# **ALERT SERVICE BULLETIN**

## **Alert Service Bulletin No. 072 Rev. A**

### **Master Contactor Replacement**

**Affected Master Contactor. Model Number STS-M12 Shown.  
Figure-1**

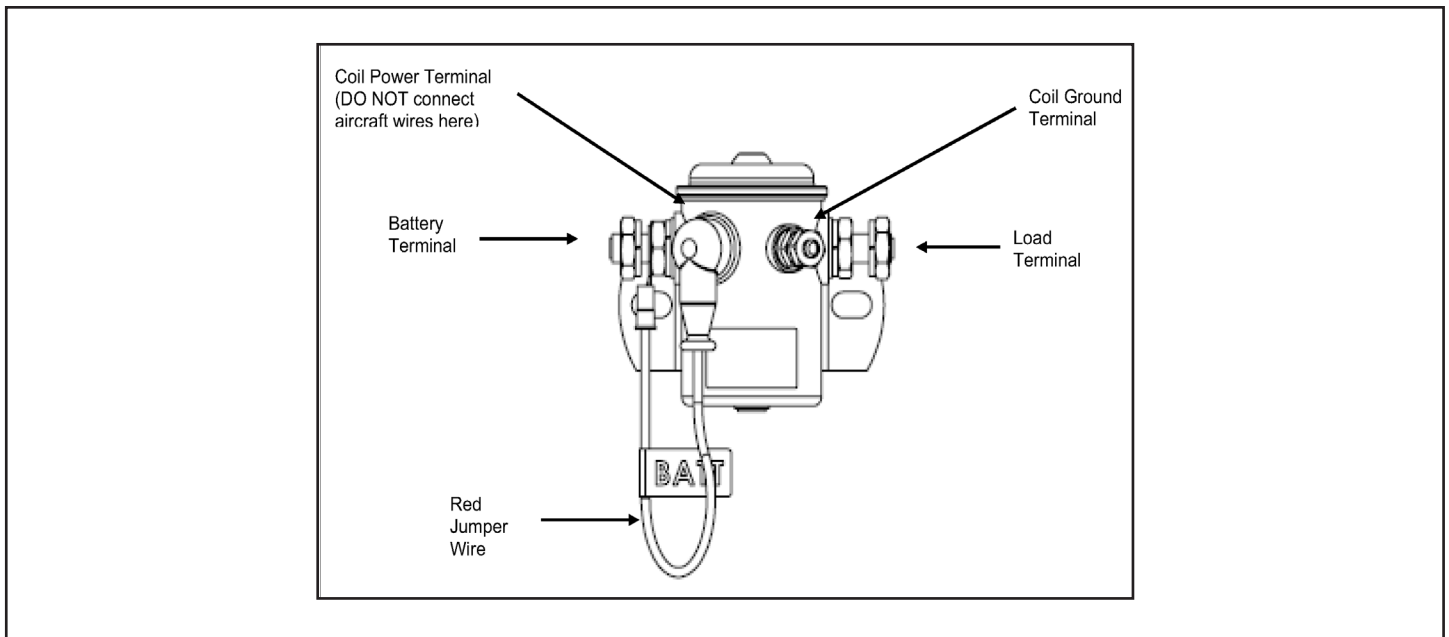
- (1) A design deficiency in the Master Contactor may cause a loss of contactor function when cycled, resulting in loss of aircraft electrical power.

- (1) This Alert Service Bulletin provides Instructions for Continued Airworthiness (ICA).
- (2) This Alert Service Bulletin provides instructions for replacement of affected HET Master Contactor part numbers STS-M12 or STS-M24 and affected HET Auxiliary Contactor part numbers STS-A12 or STS-A24 when installed as the Master Contactor.

- (1) At the next planned maintenance interval or within the next twelve (12) months, whichever occurs first, replace affected Master Contactor with one not affected by this Alert Service Bulletin in accordance with the applicable aircraft maintenance manual and/or service instructions and continue to “Return to Service” 3.C.(1).
  - (a) Refer to **Figure-2** for replacement contactor illustration. Sky-Tec Contactor P/N STS-M12 and STS-M24 with serial number H-R10001 and later will come with a red jumper wire installed from the Battery Terminal to the Coil Power Terminal. The jumper converts a 4-terminal contactor to a 3-terminal contactor.
  - (b) This configuration requires no alteration prior to installation. Use the vacant Coil Ground Terminal for control wire connection.
